UNITED STATES
NUCLEAR REGULATORY COMMISSION
REGION III
799 ROOSEVELT ROAD
GLEN ELLYN, ILLINOIS 60137

Docket No. 50-263

CONFIRMATORY MEASUREMENTS PROGRAM PERFORMANCE HISTORY FOR MONTICELLO
NUCLEAR GENERATING PLANT

Figure 1

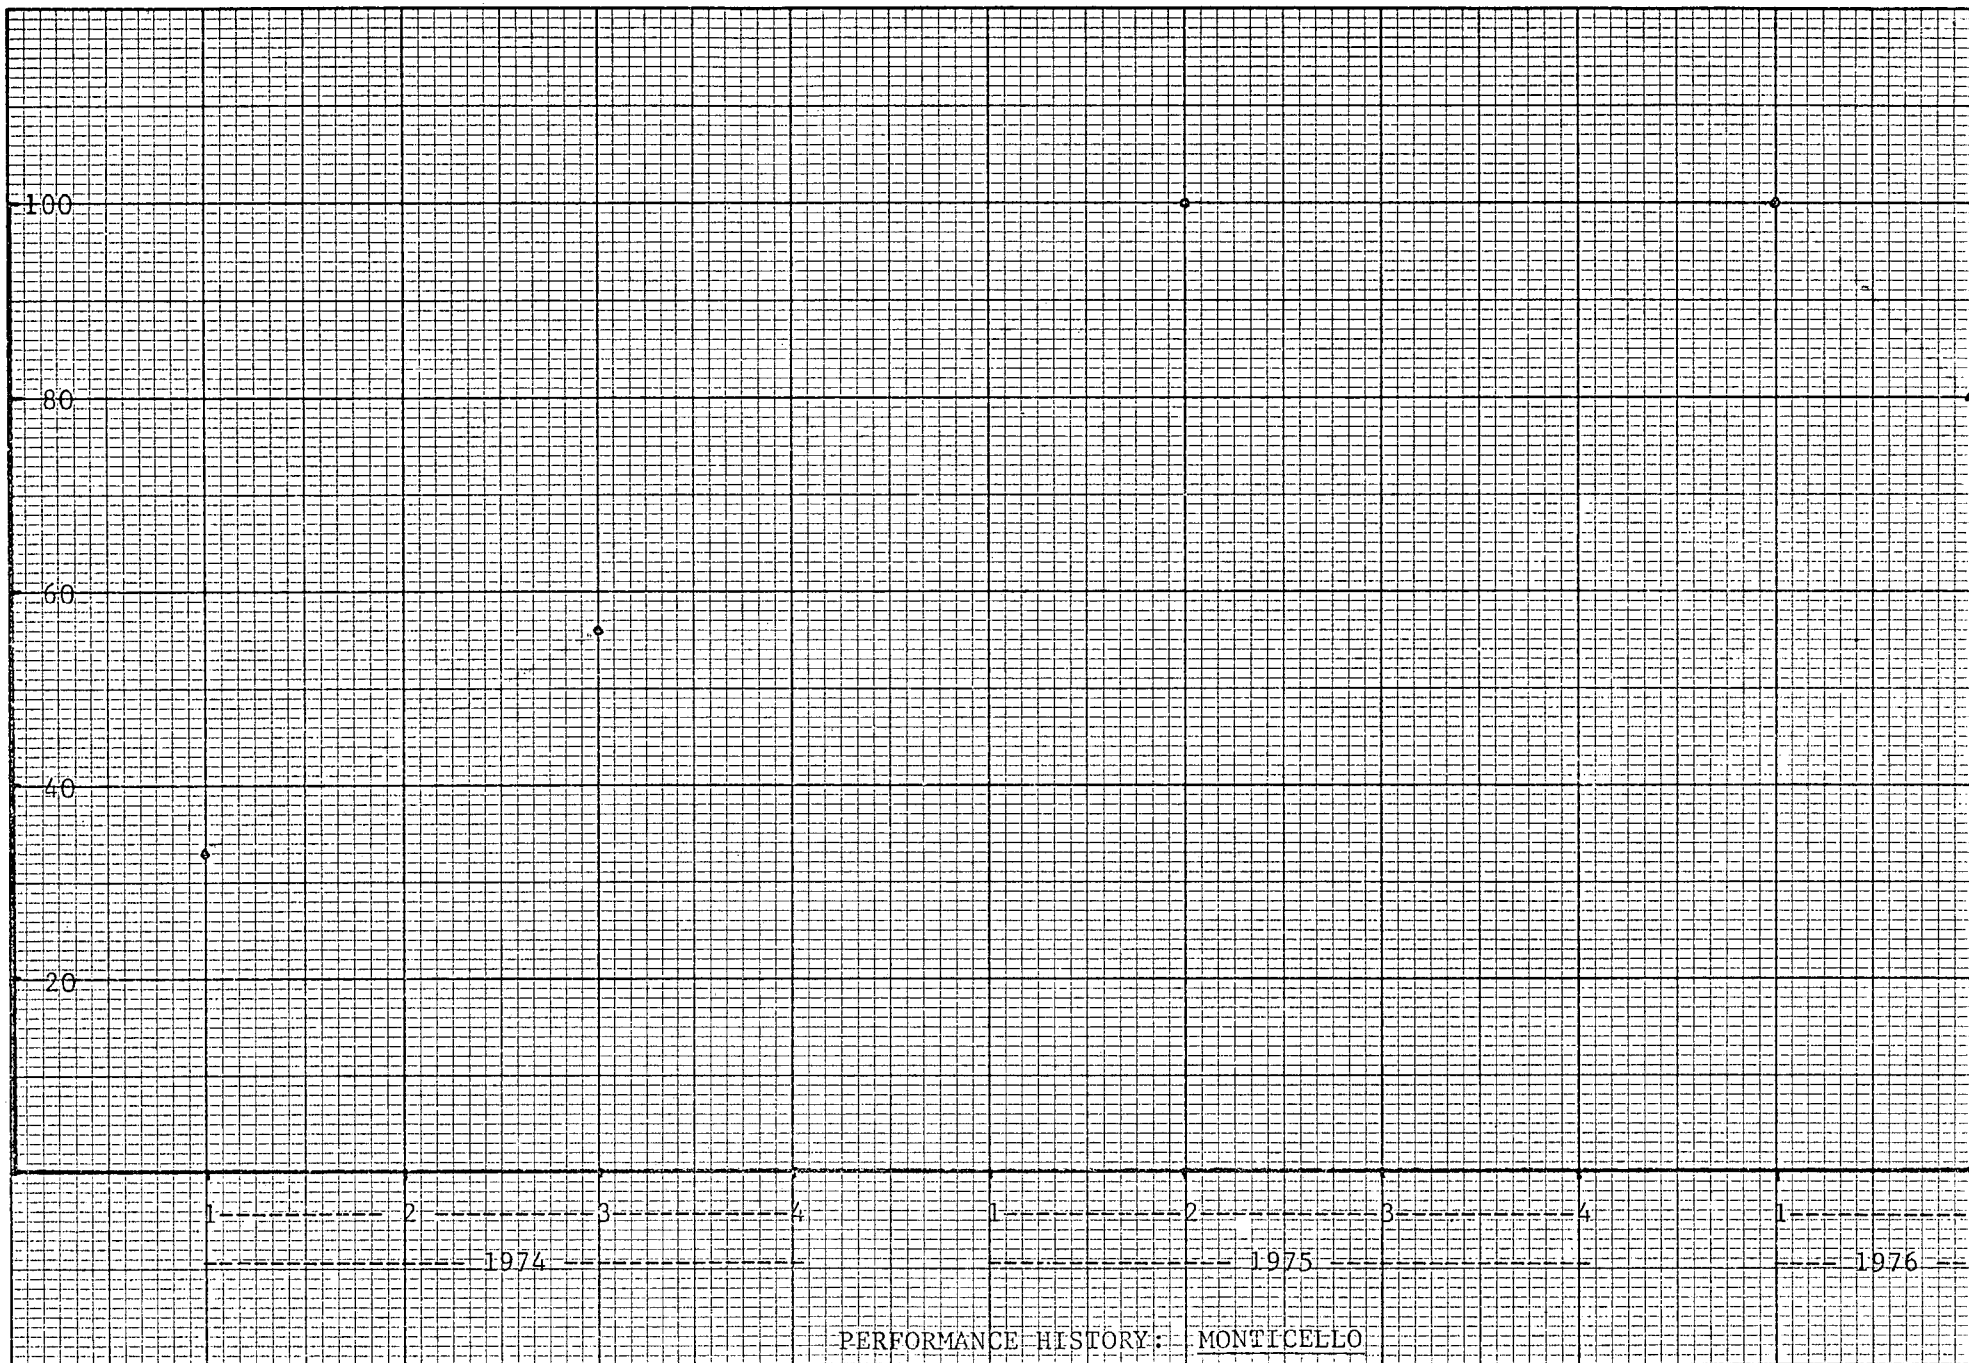
The results of the Confirmatory Measurements Program were reviewed using the NRC Computer Data Analysis System. The summary results of these analyses are presented in Table 1. Figure 1 presents performance results as a function of time (trend analysis) for each inspection sample collection period.
